- 3 LDA2021/0375**
114-116 Victoria Road Gladesville
Construction of a six storey residential apartment building comprising 55 apartments with three levels of basement carparking with 74 spaces.

City of Ryde Local Planning Panel Report

DA Number	LDA2020/375
Site Address & Ward	114-116 Victoria Rd Gladesville Lot 1 DP 785002 East Ward
Zoning	B4 Mixed Use
Proposal (as amended)	Construction of a six storey residential apartment building comprising 55 apartments with three levels of basement carparking with 74 spaces. The above proposal is integrated development under the Environmental Planning and Assessment Act 1979, as the subject site requires a dewatering licence. The relevant approval body is WaterNSW.
Property Owner	Zonie Properties Pty Ltd
Applicant	Zonie Properties Pty Limited atf Zonie Group Unit Trust
Report Author	Kimberley Kavwenje, Senior Coordinator Development Assessment

Figure 19 Landscape plan showing communal open space to the rear

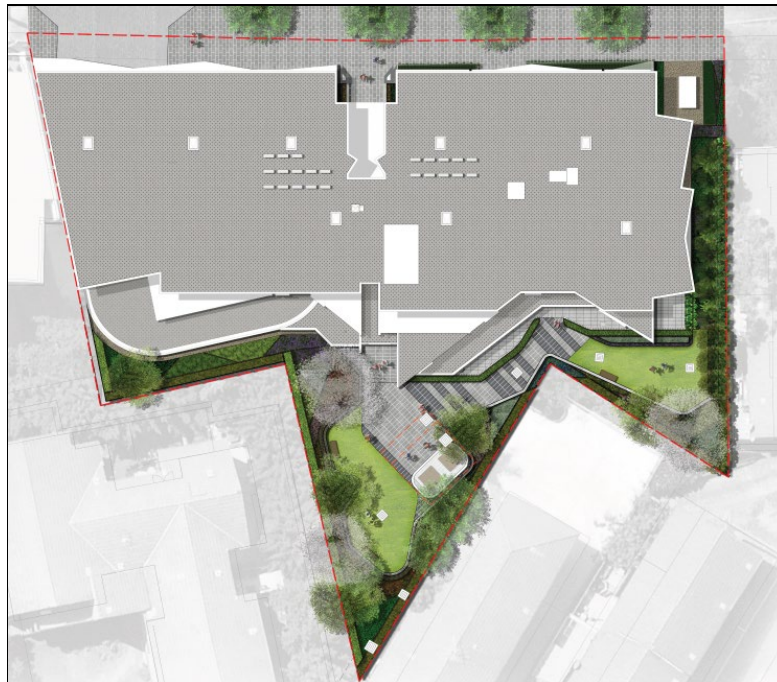
The proposal has been amended in response to the relationship of the communal open space with the stepped rear boundary and resultant pinch points. The proposal provides for a consolidated communal open space which is directly accessible from within the building and given its western orientation receives solar access in the afternoon (**Figure 19**). Further details have been submitted and the proposal including the provisions of plantings within the planter boxes with appropriate soil depths and provision of replacement canopy trees. The proposal is considered satisfactory by Council's Consultant Landscape Architect/Arborist.

Figure 1 Soil depth of proposed planter associated with G.04

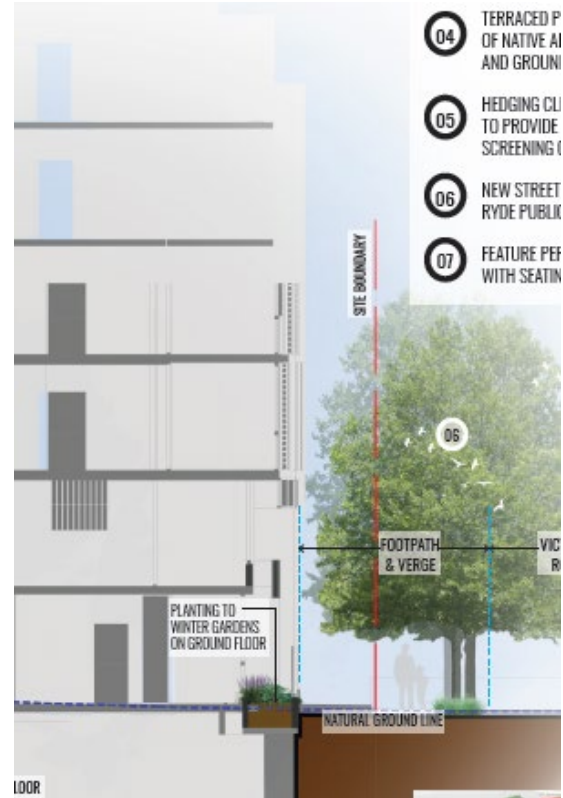
It is not clear from the drawings how the planters shown along the unit interface to Victoria Road will achieve adequate soil depth to provide a measure of privacy. No deep soil is currently shown below these planted areas and this is not acceptable. The basement should be moved away from the area in which the planting is proposed.

The proposal includes a raised planter box associated with G.04 and G0.5. The basement includes a reduced floor to ceiling height at this location (visitor space 10,11 and turning bay in addition to the hydrant pump room and electrical room) to facilitate an increased depth of soil to achieve the desired landscaping for privacy.

Figure 21 Proposed balconies of 1.01, 1.02 and 1.03

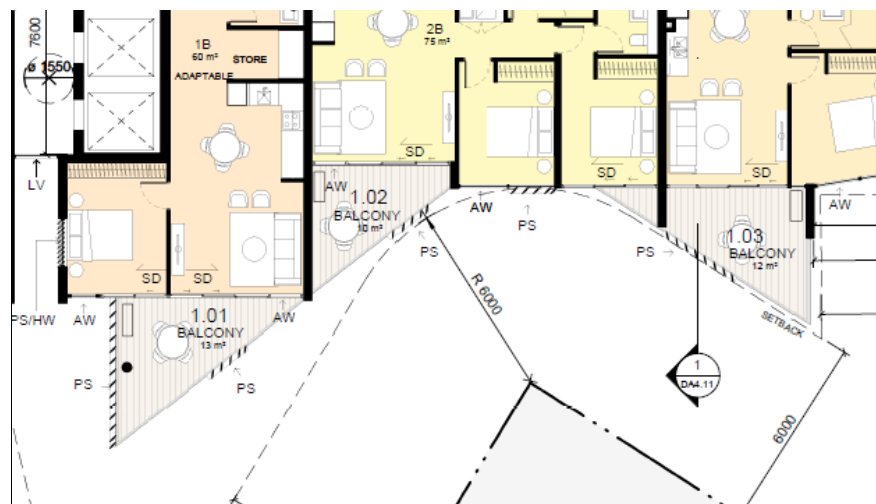
The balconies associated with 1.01, 1.02 and 1.03 (**Figure 21**) are designed with a shorter depth where they adjoin a corresponding longer depth of balcony to prevent direct overlooking between apartments. The balcony of 1.02 is recessed and there is a solid wall between the balcony of 1.01 to prevent overlooking. The balcony of 1.01 contains a partial louvered screen where the balcony depth widens to prevent views in a southerly direction and achieves reasonable privacy between balconies. The balcony associated with 1.03 contains an angled privacy screen which also prevent direct overlooking.

Figure 25 Windows associated with bedrooms where 3m side setback proposed

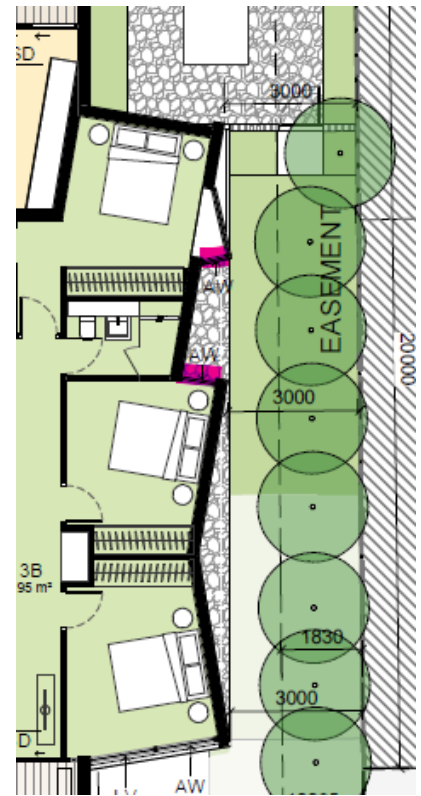
The proposal provides for a nil setback along the northern side boundary (shared with 120 Victoria Road) and 3 metres from the southern side boundary (shared with 6 Pearson Street). The 3 metre setback is associated with blank walls adjoining bedrooms. The windows associated with these bedrooms are recessed and oriented to the east and west to ensure there is no adverse privacy impact (**Figure 25**).

Figure 31 Shadow diagrams between 1pm - 3pm for Units 1.01, 2.01, 3.01 and 4.01

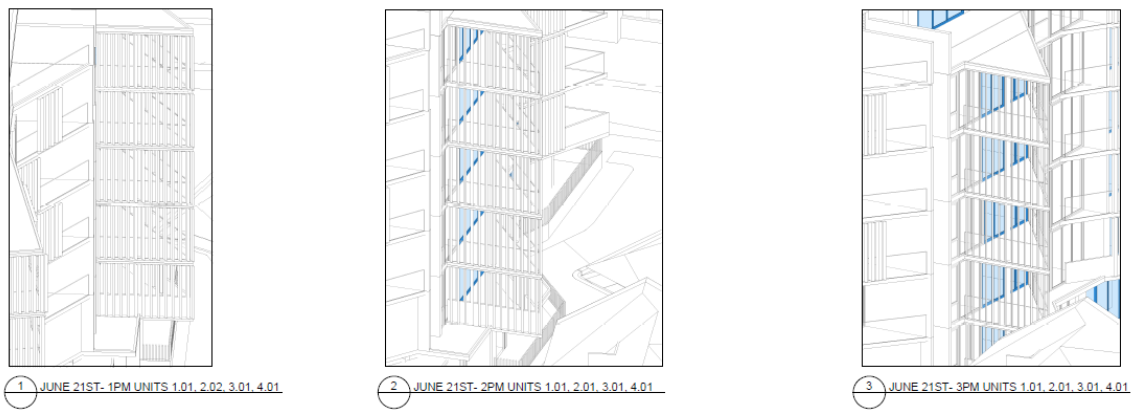
The apartments where there is a difference of opinion includes G.01, 1.01, 2.01, 2.10, 3.01, 4.01 and 1.07. The apartments 1.01, 2.01, 3.01 and 4.01 will receive solar access between 2 – 3pm only (**Figure 31**). It is not clear given their positioning within the rear western elevation when further solar access is achieved in order to be considered compliant.

Figure 32 View from the sun diagrams 1pm and 2pm in which Unit 1.07 does not receive sunlight

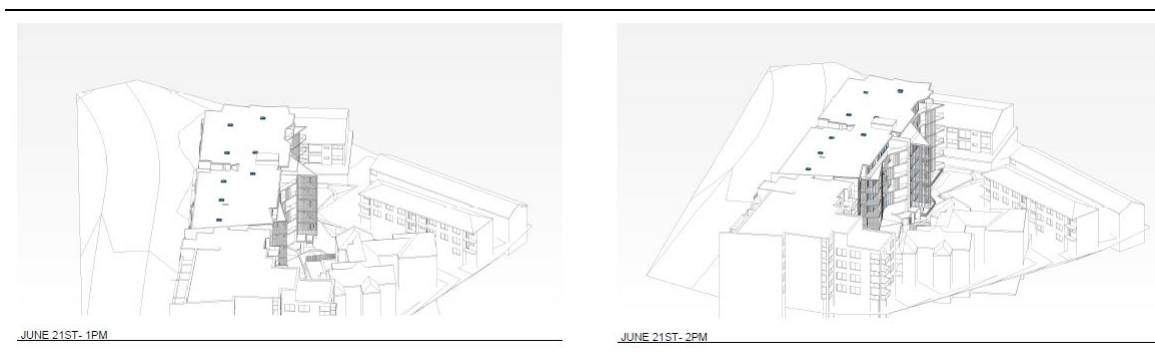
Unit 1.07 configuration (**Figure 22 above**) does not contain a living area within the eastern elevation which receives solar access between 9am and 11am. It is a bedroom which receives sunlight. The living area is positioned within the rear western elevation and does not receive sunlight until 3pm. The view from the sun diagrams at 1pm – 2pm are shown in **Figure 32**.

Figure 33 Further shadow diagram provided for 1pm for Units 1.01, 2.01, 3.01 and 4.01

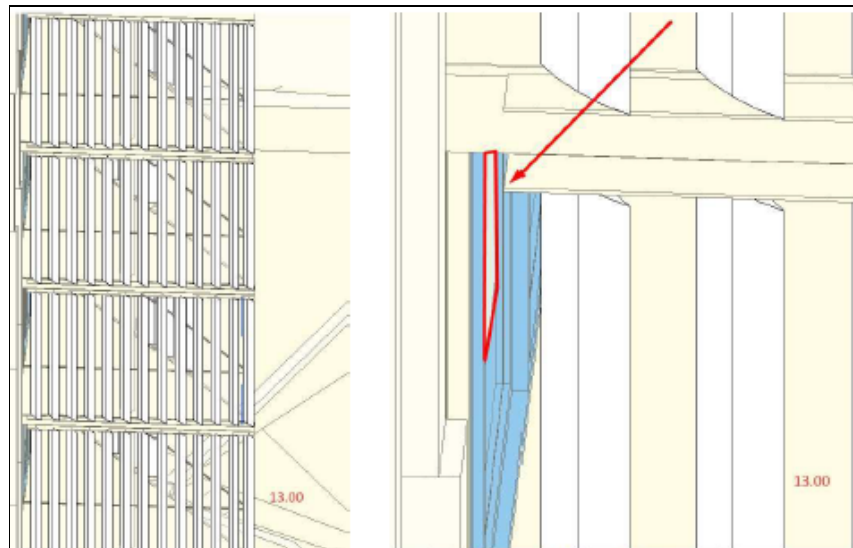
The applicant indicates they do not agree with the assessment in regard to Units G.01, 1.01, 2.01, 3.01 and 4.01. The applicant indicates these apartments receive sunlight at 1pm and submitted further shadow diagrams on 9 November 2021 (**Figure 33**). If these apartments were included, 38 units would receive the required solar access equating to 68% and compliance would remain non-compliant.

Figure 34 View from the sun diagrams between 1pm - 3pm for Units 2.10, 3.10 and 4.10

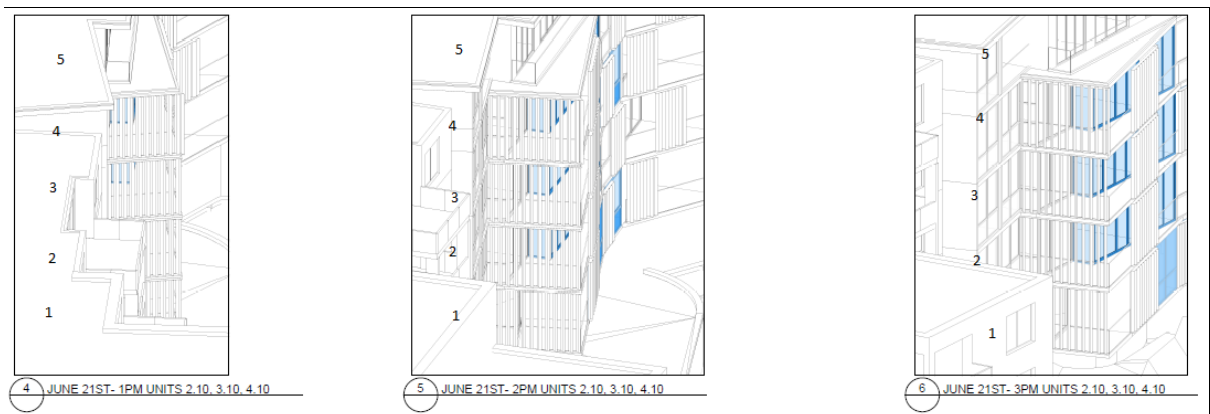
Unit 2.10 does not receive sunlight at 1pm, although does receive sunlight between 2pm and 3pm (**Figure 34**).

Figure 35 Building height plane as viewed from Victoria Road

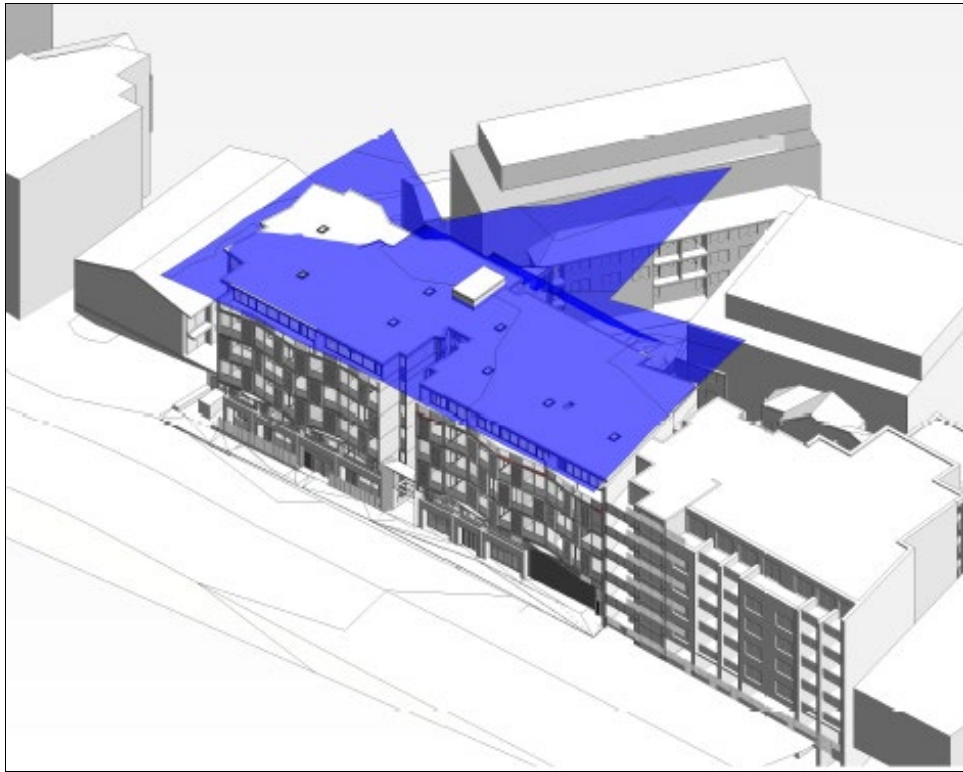
The applicant has submitted a Clause 4.6 request prepared by ABC Planning dated October 2020 (**Attachment 4**) to vary the development standard. The variation occurs primarily to the lift overrun but also occurs to the south-western corner of Level 5 (**Figures 35 - 37**). The written variation indicates a maximum height of 20.07m is

Figure 41 Communal open space 120 Victoria Road shown in red, the height breach proposed shown in blue and views marked

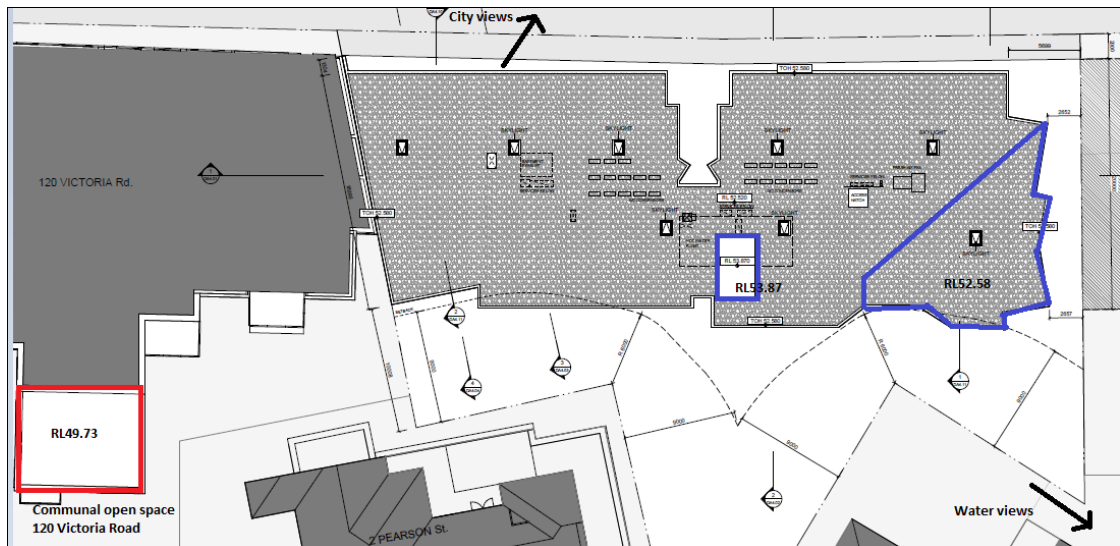
Whilst the proposal does result in a height exceedance, the views that are impacted of the city do not occur as result of the height exceedance (**Figure 41**). The height breach occurs at the rear south-western corner of the building and associated with the lift over run. The proposal has a nil setback along the northern boundary which is permitted under the provisions of 3.1.5(c) of RDCP. The view loss occurs from a compliant development in terms of height and setback. The views to the city are obtained across the front of the property towards Victoria Road where the development complies with the height standard. In order to retain the city views, the height of the development would need to be reduced by a storey, this would result in a different development potential for the site. It is not a matter of a more skilful design given the irregular nature of the allotment. Given the view loss occurs from a compliant part of the development and in order to retain the views, it would not enable the same development potential the view loss is not considered to be unreasonable.

Comment: The proposed lift over run and part of the south western corner of the development results in an exceedance of the standard (shown in blue in **Figure 41**). 120 Victoria Road Level 6 is RL49.73. The view available to the city is attained to the south east and is not interfered with by the height exceedance which occurs at the rear of the site. Whilst the city views will be loss, the impact occurs from a compliant component of the building and the nature of the site would not afford the same development potential and protection of these views. The view loss is not considered to be unreasonable.

Figure 42 Proposal in relation to the siting of 120 Victoria Road rear setback

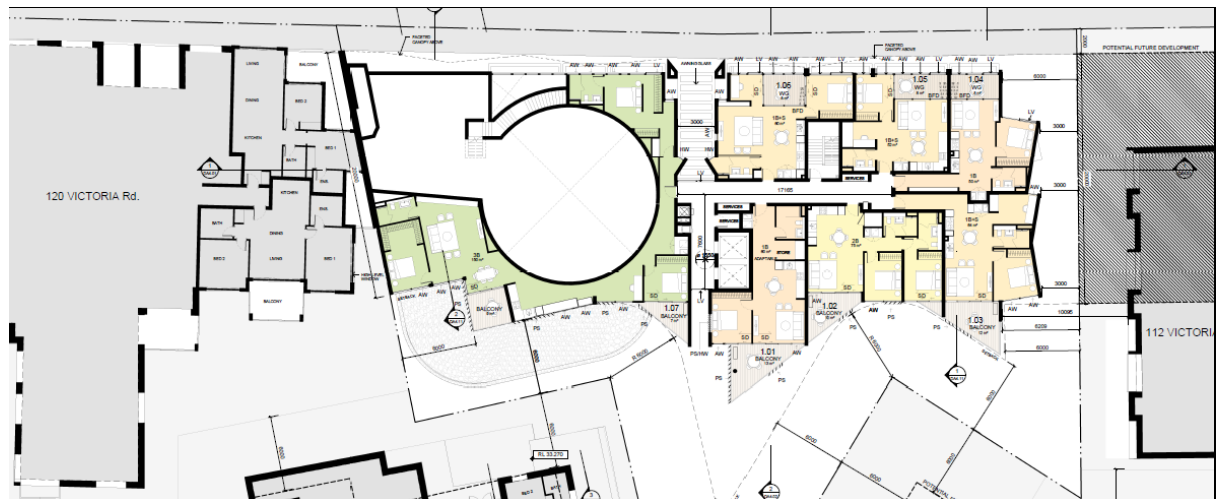
The proposed building at 114 Victoria Road Gladesville is too close to the back boundary and will protrude past the back building line of 120 Victoria road which will block air and natural lights to the building at 120 Victoria.

Comment: The subject site is irregular in shape but is different to the two adjoining properties at 120 Victoria Road and 6 Pearson Road which extends to have a Pearson Road frontage as well as frontage to Victoria Road. The proposed setback is considered to be reasonable and is not uncharacteristic of the adjoining buildings. The proposed setback of between 6 – 9m from the rear boundaries is appropriate.

Figure 43 Balconies with a northern elevation presenting to 120 Victoria Road

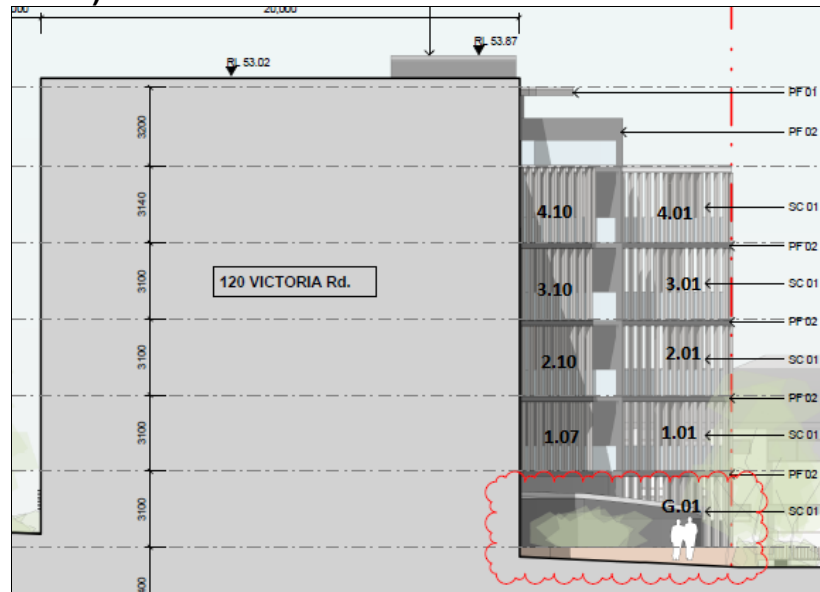
Comment: The balconies adjacent to the northern boundary (1.07, 2.10, 3.10 and 4.10) are setback 6 metres from the boundary and contain a privacy screen along the northern elevation. The balconies associated with 1.01, 2.01, 3.01, 4.01 are setback in excess of 18 metres from the northern side boundary and contain privacy screens along the northern elevation (**Figure 43**). The separation distances and provision of screens ameliorates any resultant privacy impact.
